Baldwin County Planning Commission Staff Report

Case No. CSP25-04 & PUD25-04
Southern Storage Solutions, LLC
Commission Site Plan (CSP) & Planned Unit Development (PUD) Approval
July 10, 2025

Case No. SV25-14

Southern Storage Solutions, LLC Variance Request

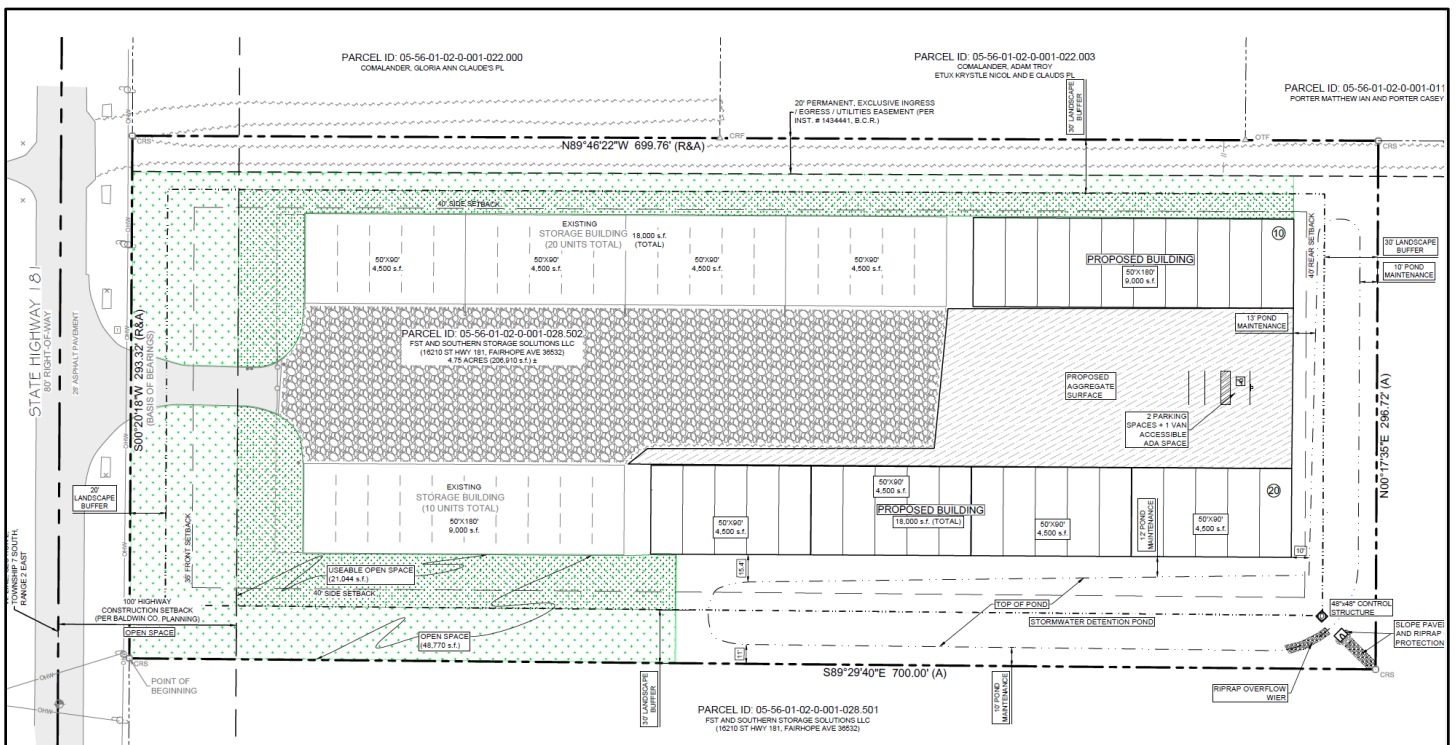
First, the required 20' maintenance easement along the northern perimeter of the detention pond is being encroached by the building by approximately 10'. A reduction in the width requirement of this easement would still allow maintenance to occur behind the proposed building location and along the southern property line. Secondly, in keeping with the desire to adhere to the requirements of the Good Neighbor Stormwater Policy and to meet water quality requirements post-development, the stormwater management facility outfall would need to be located approximately 17' – 18' from the property line instead of the required 25'. Lastly, as

a result of lot size and existing development, to meet the requirements of the Good Neighbor Stormwater Policy, the stormwater detention facility can not be placed in an alternate location on the property outside of the 30' landscape buffer. Therefore, an elimination of the required landscape buffers along approximately 2/3rds the southern property line as well as the length of the eastern property line is requested. As a result of these hardships, staff feels the granting of this variance request is in compliance with Article 8, Section 8.1 of the Baldwin County Subdivision Regulations.

Section 5.2.4(b)

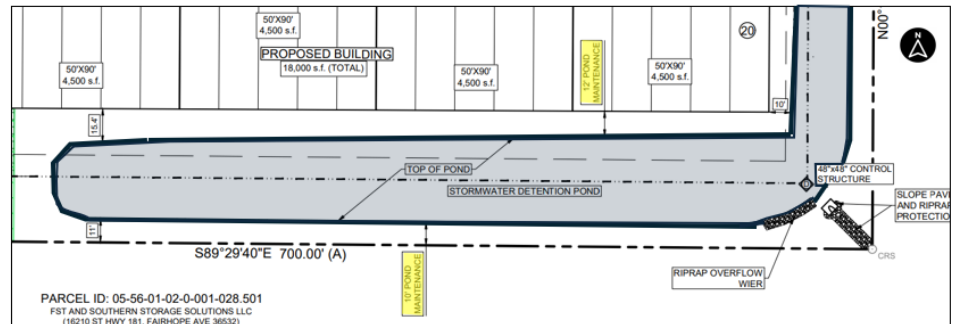
- (b) Dams or impoundments including impoundment embankments and the entire spillway and outlet structure, along with access at least 20 feet in width around the perimeter of the embankment and outlet structure, shall be retained in a common area. Maintenance of such structures shall be the responsibility of the Developer or Property Owners Association. Under no circumstances shall Baldwin County assume such maintenance responsibility. A note to that effect shall be added to the Plat or Site Plan.

Per applicant: "Based on the location of the detention/retention facility and the size needed to accommodate the Good Neighbor Stormwater Policy and meet water quantity requirements for reduction of post-development discharge rates to lower than or equal to pre-development discharge rates, the maintenance width varies from 10' to 15' around the pond. **This reduction still allows for equipment and maintenance of the pond. This is a reduction of the required 20' maintenance buffer to 10' - 15'.**"

Section 5.11.2(i)

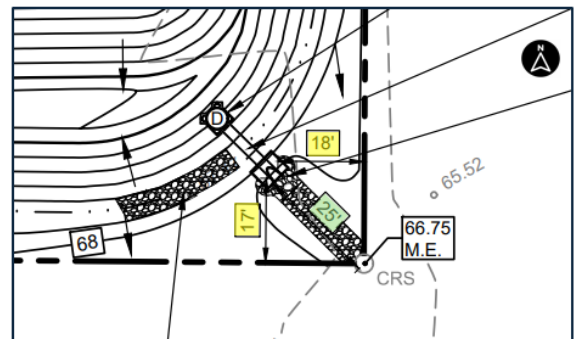
- (i) **Stormwater Outfalls.** Stormwater management facility outfalls shall be installed 25 feet from the property line and shall include velocity dissipaters as required by the County Engineer to prevent offsite erosion and allow for future maintenance. Exceptions may be approved by the County Engineer.

Per applicant: "Based on the location of the detention/retention facility and the size - 2 - needed to accommodate the Good Neighbor Stormwater Policy and meet water quantity requirements for reduction of post-development discharge rates to lower than or equal to pre-development discharge rates, the stormwater outfall (end of outfall pipe with slope paved headwall) is within 25' of the nearest property line(s). The slope paved headwall is 17' from the south property line and 18' from the east property line. This is shown on sheet C.3.0 of the civil plans. Sheet C.3.0 of the civil plans is included with the variance request. **The placement of the outfall is determined by the topography of the site and the lowest elevation for discharge.** Velocity dissipation in the form of riprap extends 25' from the end of the outfall to the discharge point of the property."
